Door handle guard

Classification - Mandatory

Applicability - All Europa aircraft

Compliance - Within the next 10 flying hours

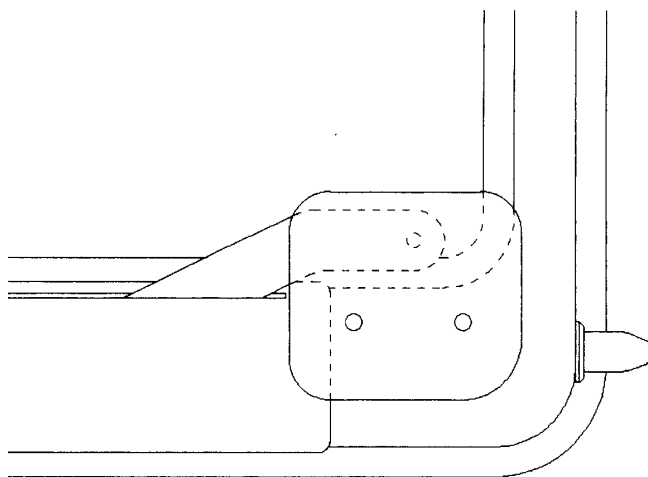
This modification introduces a guard to prevent the possibility of inadvertent operation of the door handle in flight by, for example, clothes snagging.

Prepare a flat plate as shown in the figure below. This plate can be made of 1mm thick (20 s.w.g.) aluminium sheet, or alternatively it can be made by laying up 3 or 4 plies of 'bid*. The top of the guard should be higher than the top of the inner door handle, and the back of the guard should finish just aft of the horizontal section of the handle.

If necessary, modify the inner door handle knob so that it does not project inwards beyond the inner face of the door frame.

Bond, or bond and rivet, the guard plate to the existing cover plate and door frame. Use TLPK424BS pop rivets and be sure to keep the rivets clear of the push-rod and shoot bolt.
